MOTEL COURT SUBDIVISION

APPLICATION NUMBER 12 DATE July 11, 2013
APPLICANT Motel Court Subdivision, Phase 4
REQUEST Subdivision

DETAIL SITE PLAN

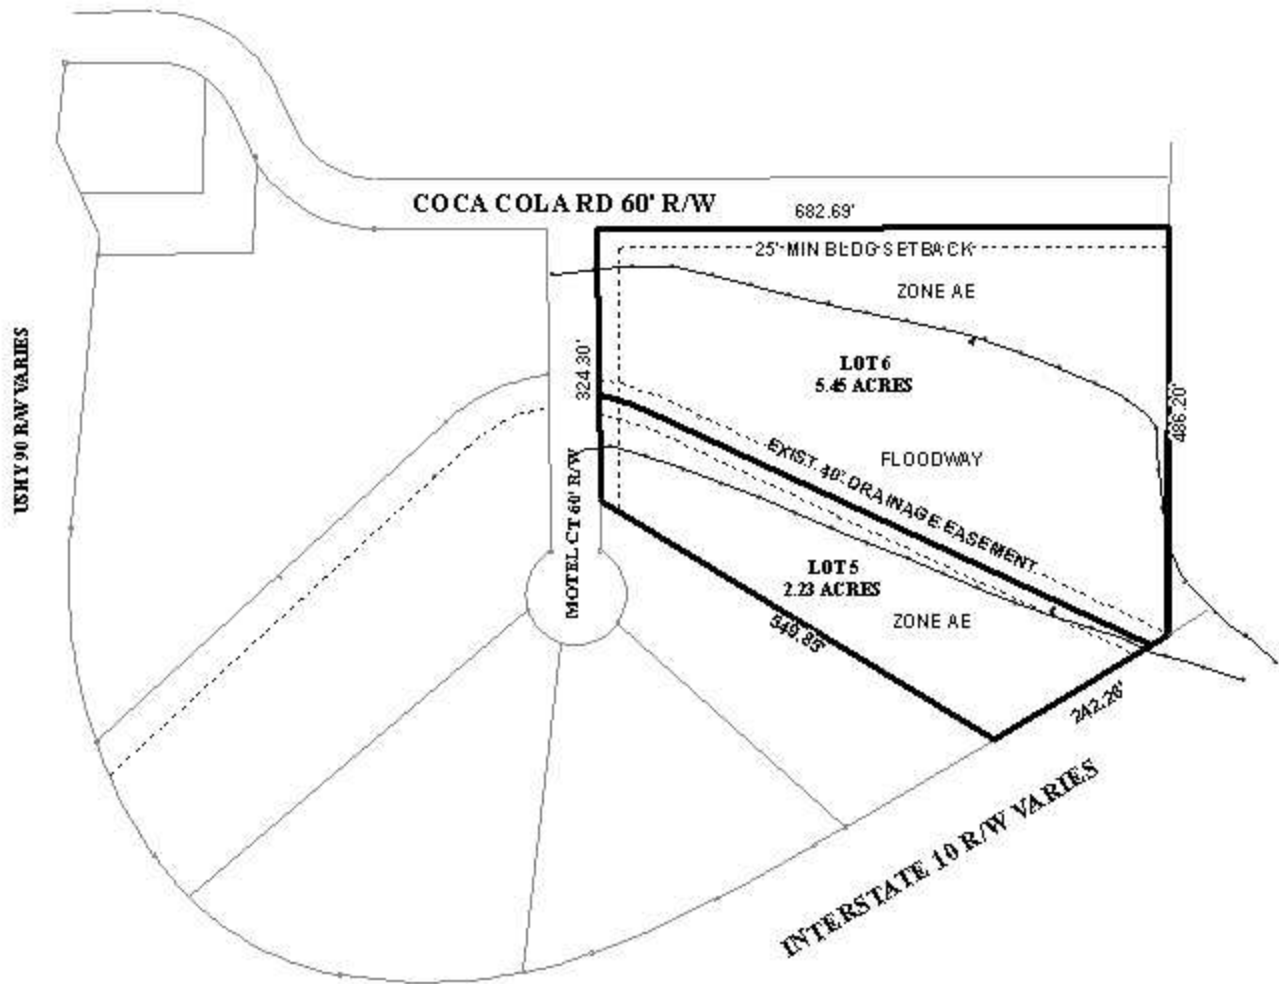
4. Dedicate a 25' radius at the northeast corner of Lot 6 to Public ROW. 5. Add a note to the Plat that no development is allowed within the existing FLOODWAY. Any proposed development will require a submittal of a Flood Study by a Licensed Professional Engineer for review and approval by the City Engineer and FEMA.

The remaining property is now presented for subdivision into two lots of record. This arrangement of the property may exacerbate difficulties faced in the previous application, by increasing the number of building sites in an extremely flood prone location. While the proposed lots are of substantial size, the site contains a large drainage ditch between both lots, is located in a floodplain, and is bisected by a floodway. In addition to being potentially environmentally sensitive, it may pose significant problems of access, and the floodway may be of such a size and shape as to make proposed Lots 5 and 6 undevelopable, or to seriously threaten any development there. As such, the applicant is advised to reconsider concentrating development in this area of the property. Furthermore, approvals from federal, state and local agencies will be required prior to the issuance of any permits.

The majority of Lot 6 is in the floodway and the remainder is in the AE floodplain; the location of the floodway may make access to Coca Cola Road more appropriate than to Motel Court, although this should be subject to City Engineering approval. As a means of access management, each lot should be limited to a single curb-cut and a note so stating should be required on the final plat.

- 1) placement of a note on the final plat stating that approval of all applicable Federal, state and local agencies is required for flooding issues, prior to the issuance of any permits or land disturbance activities;

- 3) submittal of 7 copies of the final plat for phase one;
- 4) the placement of a note on the final plat stating the driveway number, size, location and design to be approved by Traffic Engineering and conform to AASHTO standards; and

- 5) compliance with City Engineering comments: *(1. Provide all of the required information on the Final Plat (i.e. signature blocks, signatures, certification statements, legal description, required notes).2. Add a note to the Plat stating that storm water detention will be required for any future addition(s) and/or land disturbing activity in accordance with the Storm Water Management and Flood Control Ordinance (Mobile City Code, Chapter 17 , Ordinance #65-007 & #65-045).3. Add a note to the plat stating that any work performed in the existing ROW (right-of-way) such as driveways, sidewalks, utility connections, grading, drainage, irrigation, or landscaping will require a ROW permit from the City of Mobile Engineering Department (208-6070) and must comply with the City of Mobile Right-of-Way Construction and Administration Ordinance (Mobile City Code, Chapter 57, Article VIII).4. Dedicate a 25' radius at the northeast corner of Lot 6 to Public ROW.5. Add a note to the Plat that no development is allowed within the existing FLOODWAY. Any proposed development will require a submittal of a Flood Study by a Licensed Professional Engineer for review and approval by the City Engineer and FEMA).*
